## SERVICE BULLETIN

#0017

**SUBJECT:** Potential risk of shearing of control stop plate rivets

**MODELS AFFECTED:** Sling 4 and Sling 4 TSi aircraft

Figure 1 - Elevator control torque tube for Sling 4 and Sling 4 TSi aircraft

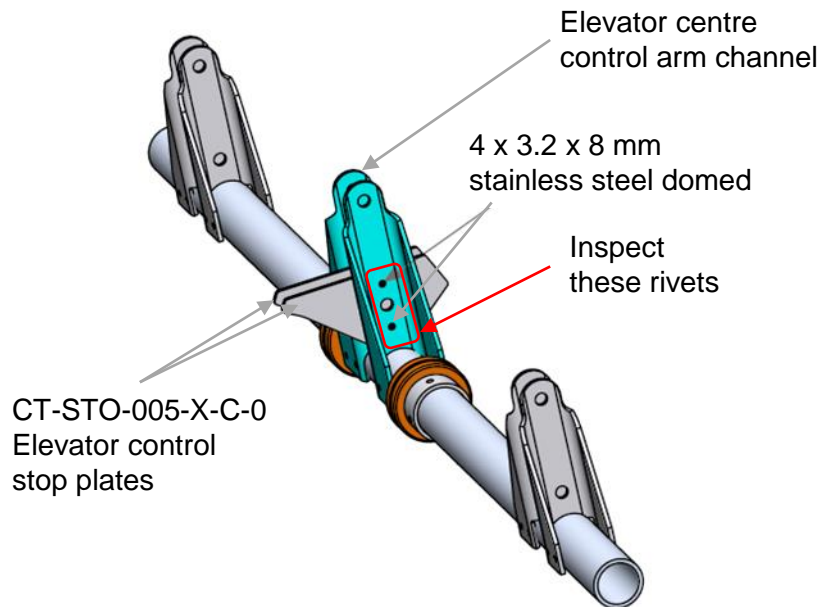
1. The rivets on the torque tube that need to be inspected are shown in Figure 1. The control stop plates (CT-STO-005-X-C-0) and elevator centre control arm channels are also shown in Figure 1.
2. Remove a front seat from the fuselage then use the 2 mm / 2.5 mm Allen key to remove the floor skin (refer to CF-SKN-016-R-C-0) shown in Figure 2.
3. The inspection region when the floor skin is removed is shown in Figure 3. Use the light source to determine if control stop rivets are aluminium or stainless steel. Use Figure 4 as a guide for making the distinction.
4. Alternatively (or in addition to using the light source) use a magnet to identify rivets. The mandrel of the aluminium rivet used is magnetic, so a magnet will attract to the aluminium rivet (see Figure 4).

Figure 3 - Region of inspection area and seat rail

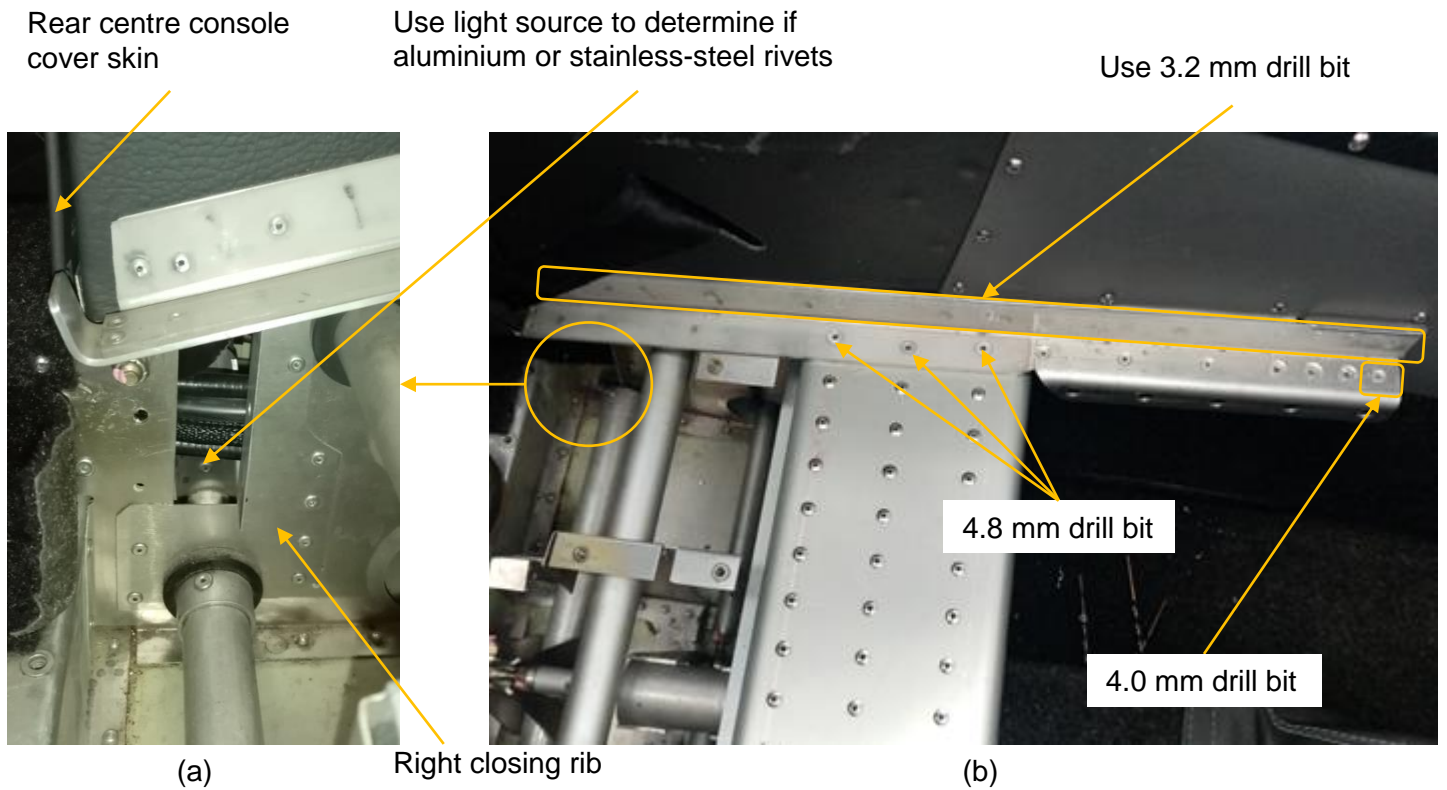
7. Drill the heads off the countersunk rivets shown in Figure 3(b) with the angle drill (using 3.2 and 4.8 mm drill bits) to remove seat rails.
8. Remove and retain all M3 / M4 screws on the aft section of the centre console to separate it from the forward section as shown in Figure 5(a).

11. Cut the cable ties that guide the centre console wiring and pitot static tubes (using the side cutter) to reduce their tautness, then use the angle drill and 3.2 mm drill bit to drill heads off the rivets on the closing rib as shown in Figure 5(b). The closing rib on the centre console RH side is shown in Figure 3(a).

17. The AN4 lock-nuts (hardware designation AN365-428A) must be tightened such that the seat belt brackets can still swivel.
18. Install the controls closing ribs (CF-RIB-009-R/L-C-0 shown in Figure 3(a)) using the 3.2 mm clecos to align the holes. Assemble with (20) 3.2 x 8 mm aluminium domed rivets.

Figure 5 – Disassembly of centre console and removal of CF-RIB-009-R/L-C-0

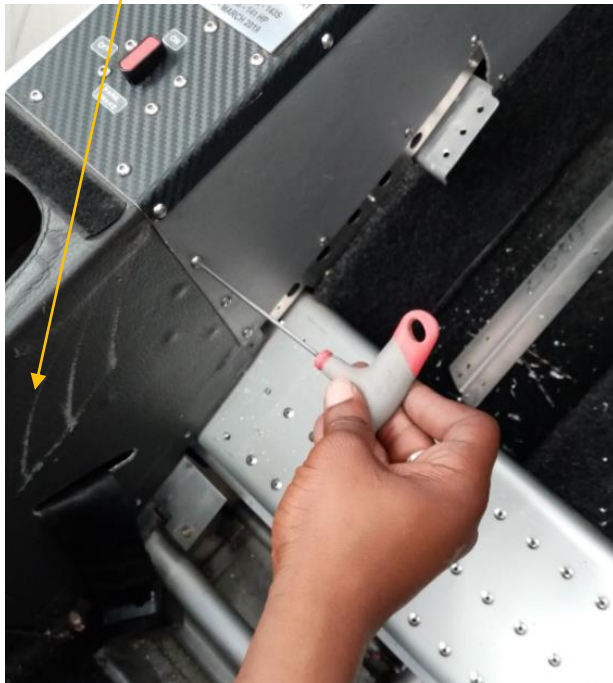
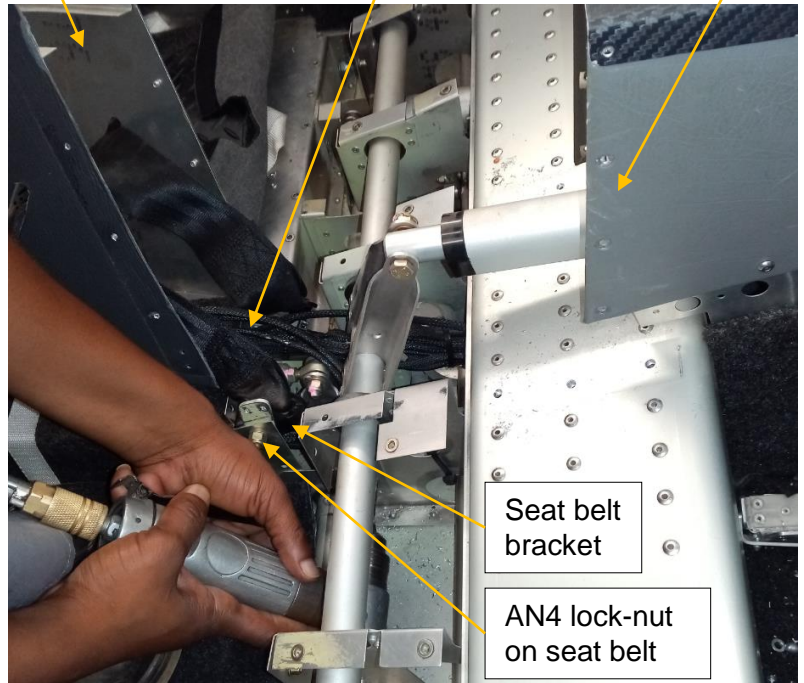
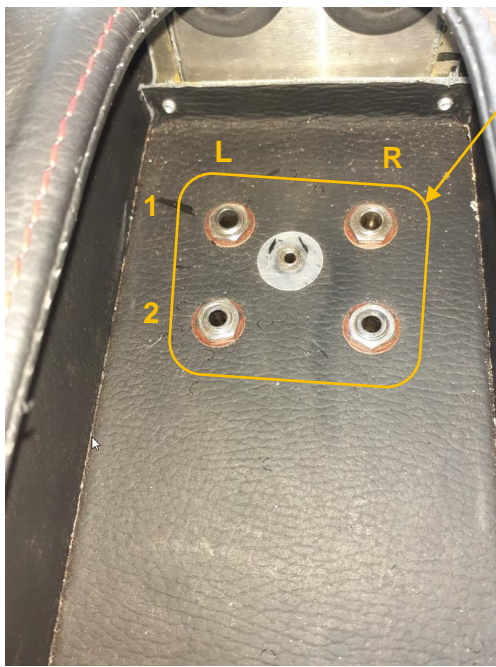
9. The aft section of the centre console must be carefully pulled away so as not to damage wiring and pitot static lines running through the console as shown in Figure 5(b). If resistance is felt separating the aft and forward centre console sections, the headset jacks should to be removed with the 14 mm spanner and socket. Be sure to label these cables left and right so that they are refitted in their original positions (see Figure 6).

19. Return the aft section of the centre console using the 2 mm / 2.5 mm Allen key and install the M3 / M4 screws (see Figure 5(a) which shows disassembly).
